Centre Wellington Scoped Tier 3 Water Budget Study: Discussion on draft Groundwater Flow Model Development and Calibration Report

Meeting Objective: To discuss and provide clarification to comments provided by S.S. Papadopoulos & Associates on behalf of Nestlé Waters Canada (NWC) on the draft Groundwater Model Development and Calibration Report prepared as a part of the Centre Wellington Scoped Tier 3 Water Budget Study.

Subject: Centre Wellington Scoped Tier Three Water Budget Assessment

Review comments on the draft Groundwater Flow Model Development and Calibration Report

Figure 1. Centre Wellington Tier Three model within the Grand River watershed sub-basins

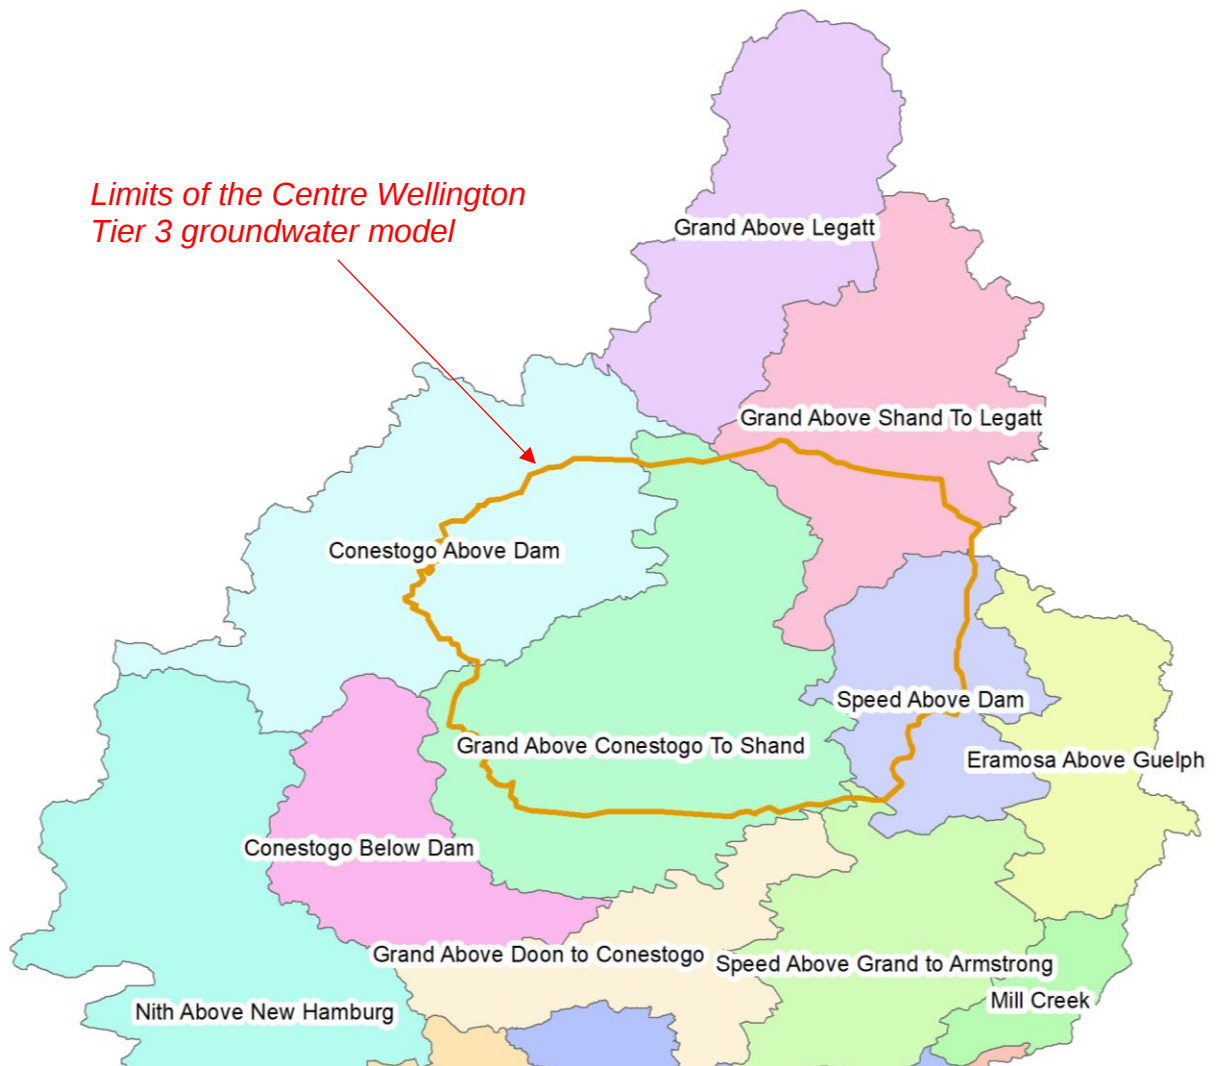
1. We recommend that the results of the Tier Three model be better integrated with the results of the Tier Two analyses.

We concur with the indication in the report that, when establishing the model domain for a groundwater flow model, it is desirable to have the model domain extend to natural groundwater flow divides whenever possible. Large rivers or topographic highs such as moraines often act as groundwater flow divides that are commonly used to establish the model limits. It is indicated on Page 2 that the Study Area boundaries were guided by surface water features and interpreted groundwater flow in the overburden and bedrock. However, referring to Figure 1 here, it is clear that the model area straddles several sub-basins of the Grand River Watershed. Although these sub-basins may not be self-contained, they are hydrologically meaningful, and integrated water budgets were developed for each sub-basin during the Tier Two study.

It is indicated in the report that the Tier Two watershed scale model was not selected for use in the groundwater modelling portion of the Tier Three Assessment due to the regional-scale focus of the watershed scale model. Our impression from Figure 1 is that no consideration was given to the boundaries of the sub-basins. In our opinion, these boundaries would have made for a more appropriate basis for setting the limits of the Tier Three groundwater model. Aligning the model with the boundaries of the sub-basins would have provided for a more meaningful integration of the Centre Wellington Tier Three model within its regional context. Since the model straddles the sub-basins it is not possible to check directly the consistency of the components of the water budgets between the Tier 2 and Tier 3 analyses.

TABLE 8 Groundwater Budget for the Study Area

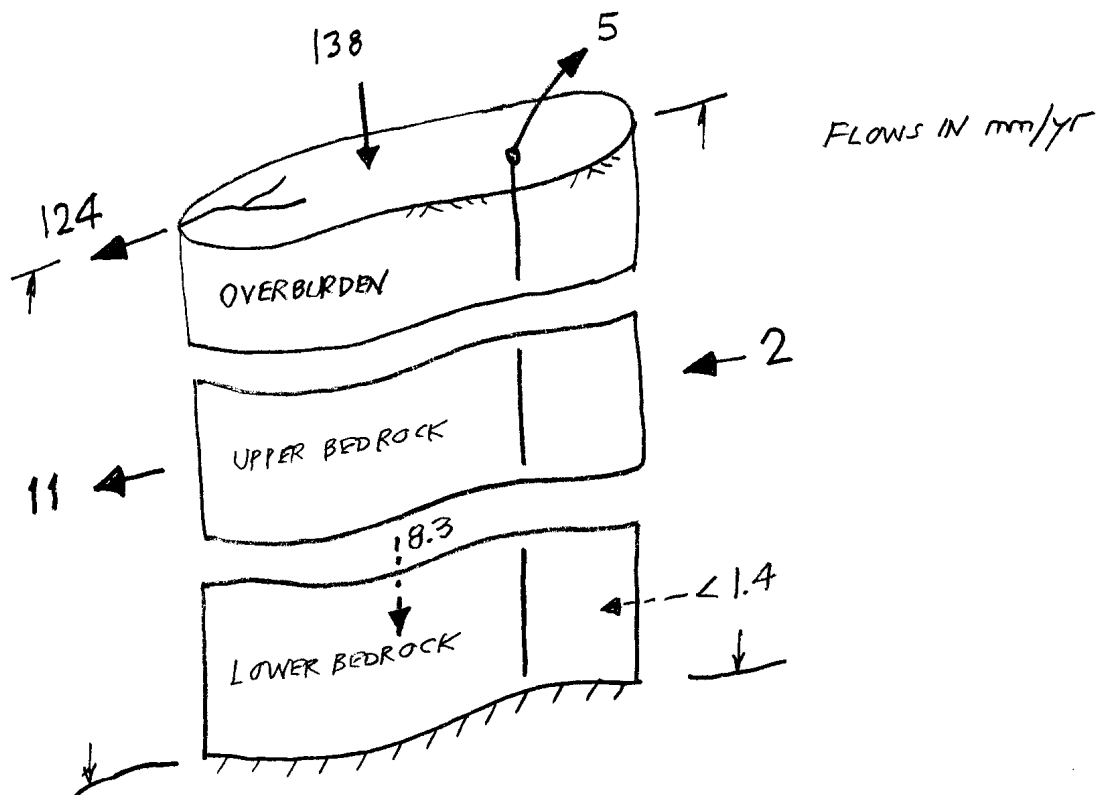
There are two key results in the overall groundwater budget that should be highlighted immediately.

- Assuming that the results presented on Table 8 are reliable, the simulated flows across the boundaries of the model are an insignificant portion of the total water budget. Therefore, in answer to a key question that has been asked previously, “Where does the water come from?”, the answer inferred from the modeling is: “From recharge over the model area.” 98% of the inflow to the model comes from recharge, and 88% leaves as groundwater discharge to surface water features. Figure 4 is particularly evocative in this regard, there is a well-developed surface water network in the model. We suspect that most of the recharge that enters the groundwater system discharges to surface water features within a relatively short distance.

- The results on Table 8 show that the groundwater takings – that is, the total groundwater takings, not just municipal pumping - represent only 4% of the inflow to the model. That is small, regardless of the criterion anyone uses to assess the relative magnitude of the pumping. We expect that if there was no pumping at all, the 4% would be split between groundwater discharge to streams and outflow across the southern boundaries of the model. Since the NWC Middlebrook well is close to the southern boundary of the model, any pumping from the well would probably be balanced by a small reduction in the outflow across the southern boundary and a reduction in groundwater discharge to the streams that leave the Study Area. It is important to note that the Middlebrook well would not be competing for water with the municipal supplies. We expect that a significant increase in municipal pumping would come at the expense of water available to the Middlebrook well. But it does not work the other way around – pumping from the Middlebrook well would be unlikely to cause a reduction in the water that can be withdrawn for municipal supplies.

Figure 2. Conceptual groundwater inflows and outflows for the Study Area

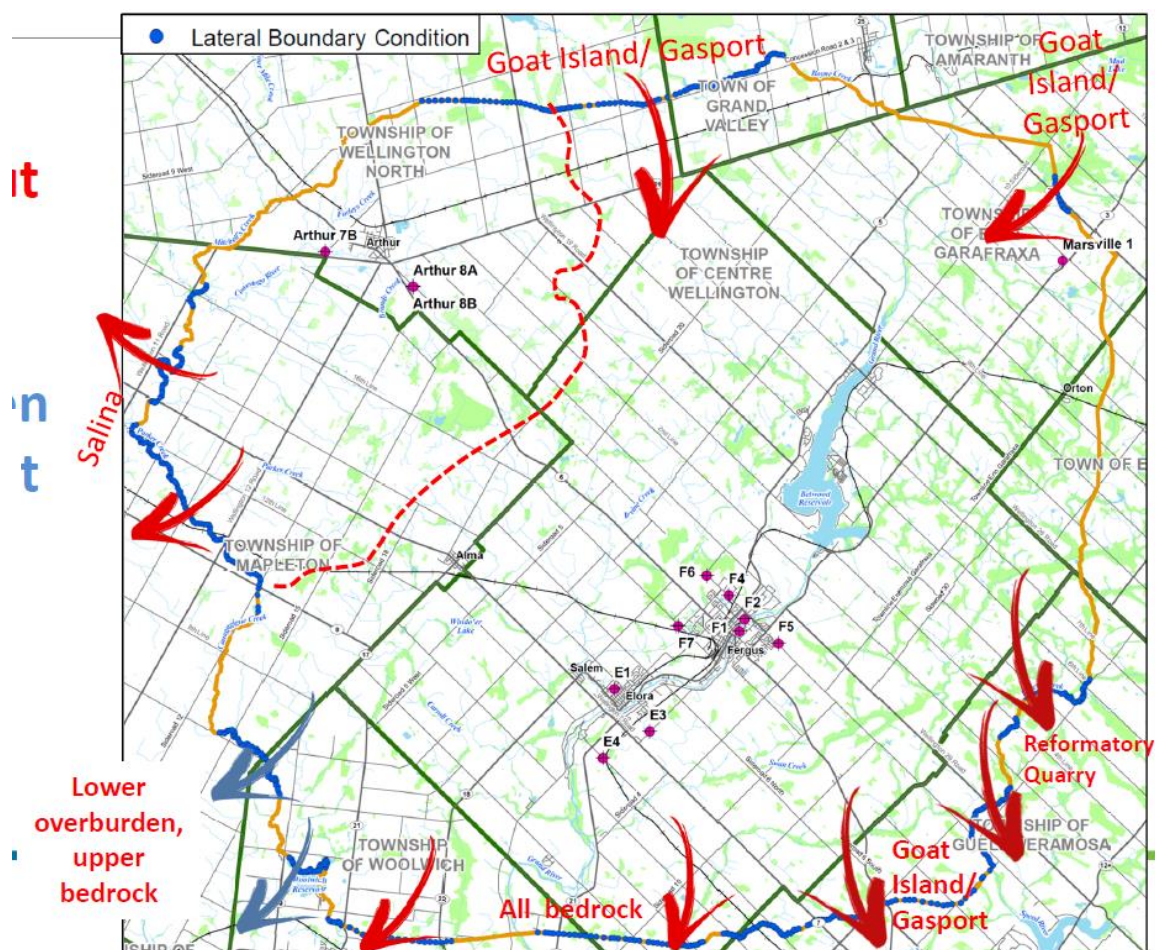
4. To be most useful in supporting the understanding of the hydrogeological setting, we recommend that the reporting of groundwater flows be expanded.

As indicated in the previous comment, only the overall simulated groundwater budget is presented, and this serves only to confirm that there is overall consistency between groundwater inflows and outflows. To be genuinely useful, the reporting of the modeling should attach magnitudes to the flows indicated in the conceptual model reproduced here in Figure 2.

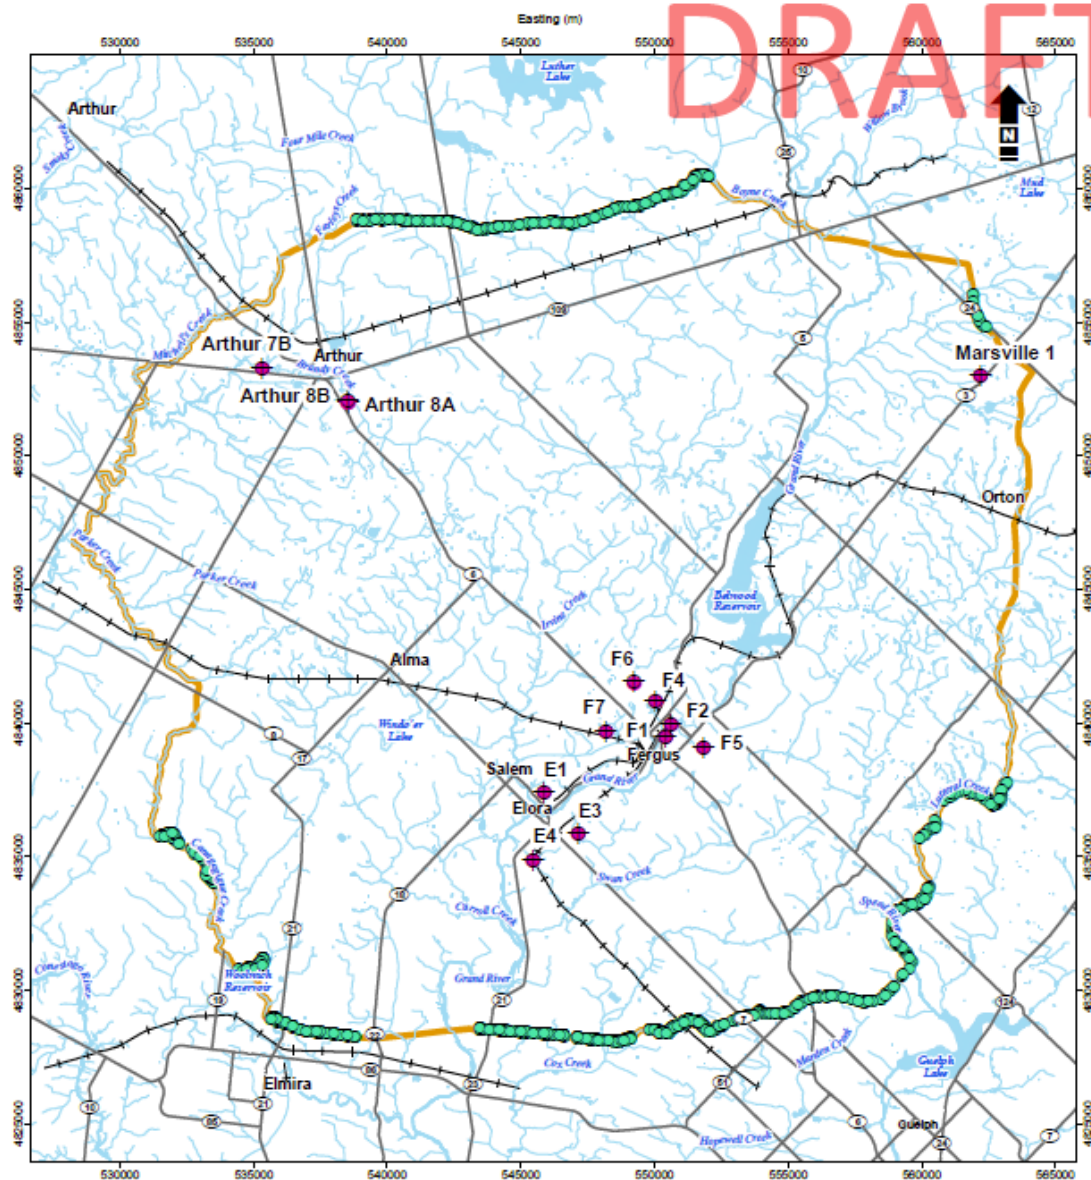
The map of the boundary conditions for the Lower Bedrock Aquifer is reproduced below from Figure 5 of the report. The green circles denote sections along the perimeter of the model along which the groundwater levels are specified, thus allowing water to enter or leave the model area from areas outside the model. As shown in the figure, these sections are relatively long.

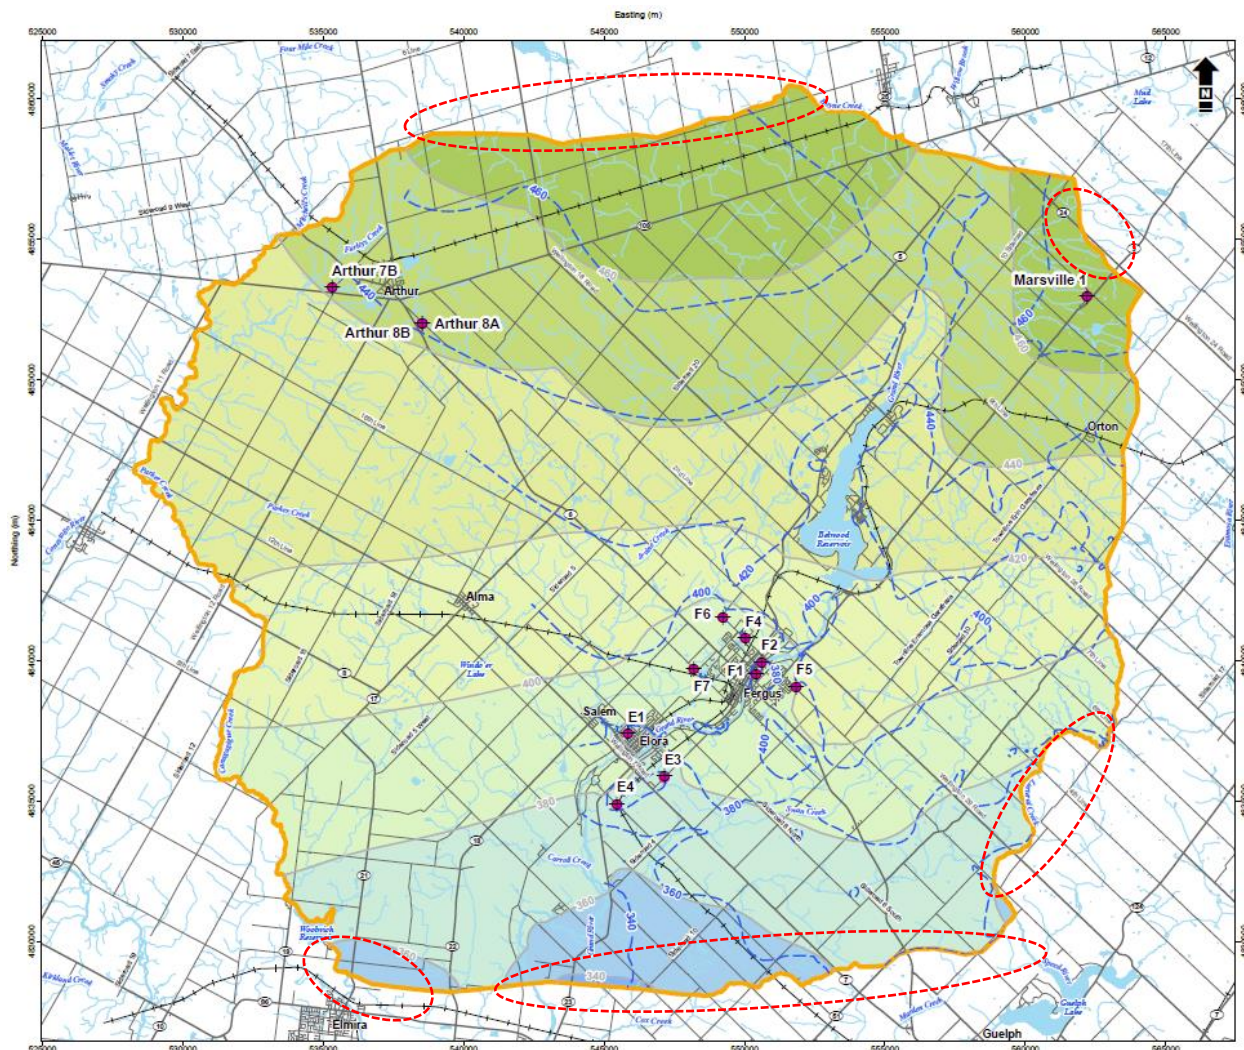
The map of the calculated groundwater levels in the Lower Bedrock Aquifer is reproduced from Figure 18 of the report. The red ellipses identify the sections of specified groundwater levels. The spacings of the contours suggest that the flow across the model area is relatively uniform. At first glance, it appears that the inflows and outflows must be correspondingly relatively large. However, referring to Table 8, the *total* cross-boundary flows comprise only a small portion of the water budget (2 mm/140 mm for inflows and 11 mm/140 mm for outflows). This does not appear to be consistent with the clear, general north to south flow patterns shown in Figure 18. Are the lateral flows into and out of the Lower Bedrock Aquifer really that small?

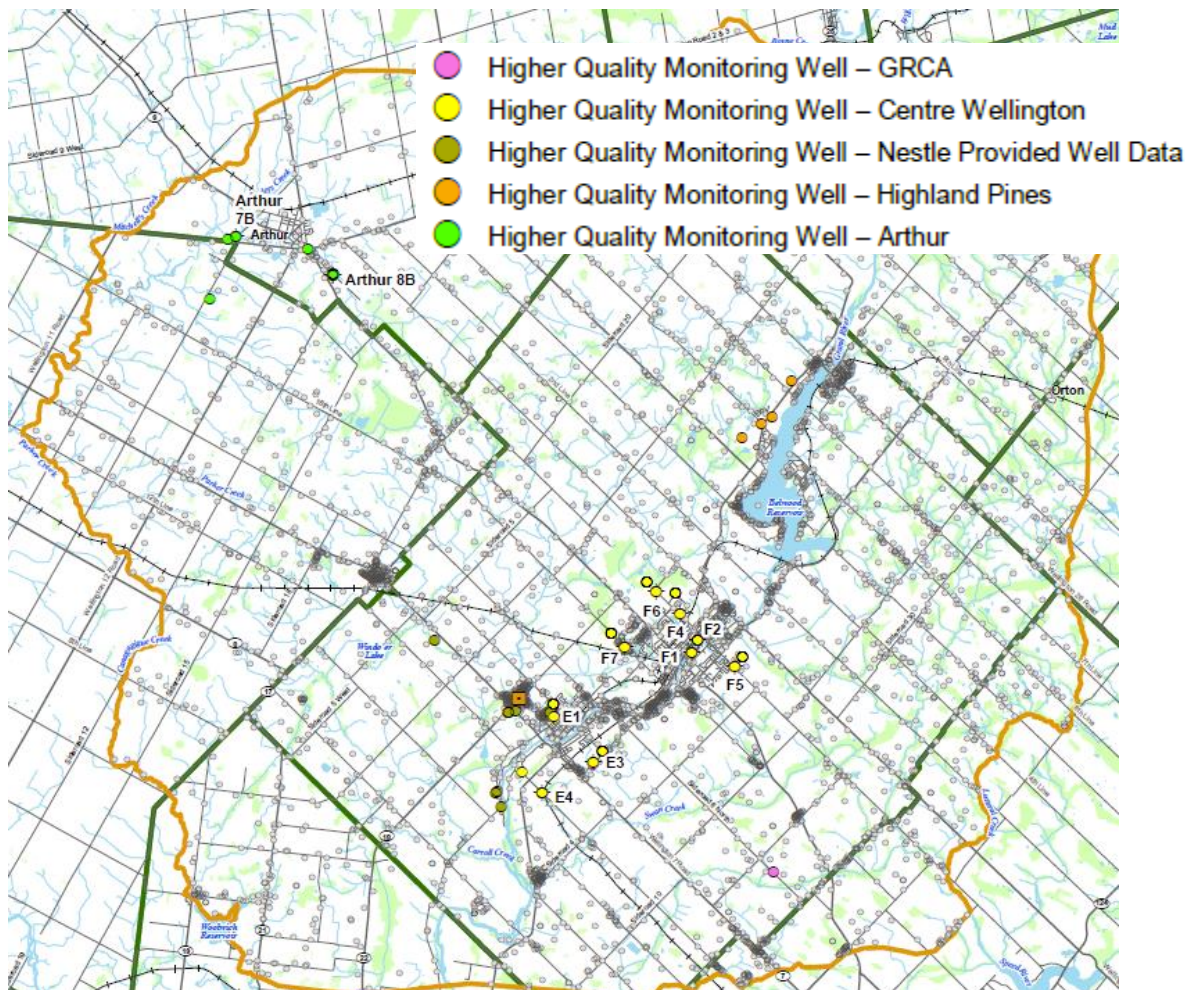
The match to the water levels from the high-quality targets is shown in format in Figure 10. A different format is adopted in Figure 11 to illustrate the match to all of the calibration targets. Goodness-of-fit statistics are reported on Page 27 of the report, but it is not indicated whether the statistics apply to the high-quality or low-quality targets.

Referring to Figure 10, are the simulated levels on average higher or lower than the targets? In the case of the pumping wells, it is clear that the observed water levels vary over relatively wide ranges. In the case of well F4, the reported range in the observed water levels is from about 353 m asl to 424 m asl, a range of **71 m**. Is it possible that the levels shown for all of the municipal production wells might represent the full ranges of water levels under *both* pumping and non-pumping conditions? Does this make sense considering that the simulation is supposed to be representative of steady-state conditions?

Matrix provided further discussion on their approach to steady state calibration. SSPA requested two versions for the steady state model calibration chart, one with the high-quality data and one with the low-quality data.

- The draft Groundwater Model Calibration report will be updated with the following:
 - a figure showing cross-boundary groundwater flows
 - independent steady state calibration scatterplots for high-quality data and low-quality data. a cumulative probability distribution plot of residuals

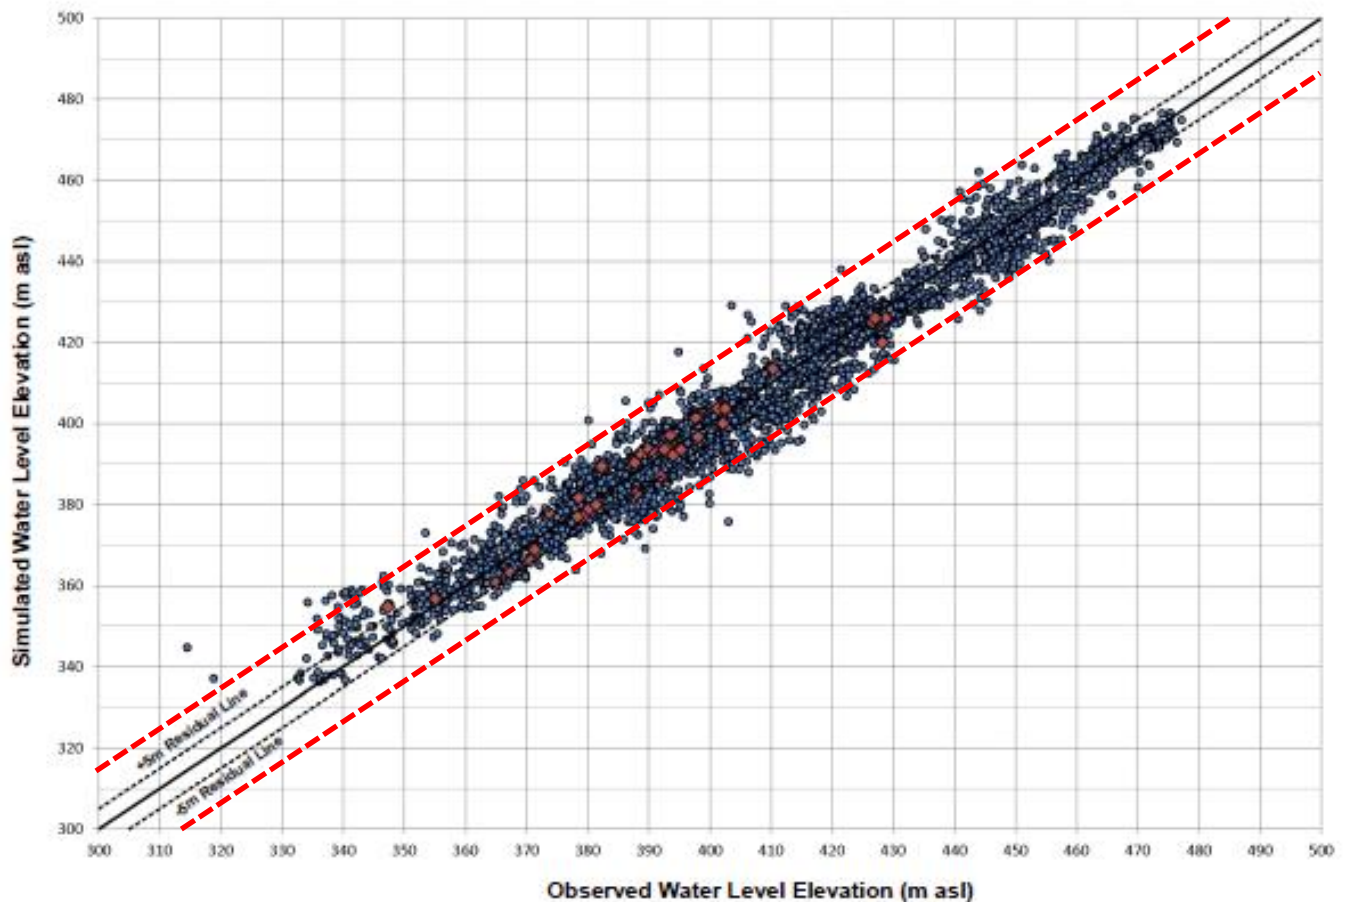
The map showing the locations of targets for the model calibration is reproduced from Figure 8 of the report. As shown in the figure, the high-quality targets are concentrated around the Fergus and Elora municipal wells. There are no high-quality targets over much of the Study Area. It is indicated that the model developed by Golder (2013) was considered for use in this project but was not applied because of the advances made to the overburden and bedrock conceptual geologic and hydrostratigraphic models in this area since completion of the Golder (2013) report. What new hydrogeologic data are available since 2013 to update the characterization of the groundwater system? What new wells have been drilled, logged, and equipped for continuous water level measurements?

The well records for private domestic wells cover the Study Area. However, the limitations of the information from these records are evident from Figure 11 of the report. Bands of model mismatch of ± 5 m are shown in Figure 11. In our opinion, these bands are much too narrow to provide a sense of how reliable the water level might be at a specific location. As indicated by the dashed red lines that have been added below, bounds of ± 15 m provide more realistic impressions of the differences between the model results and the water levels reported in the water well records.
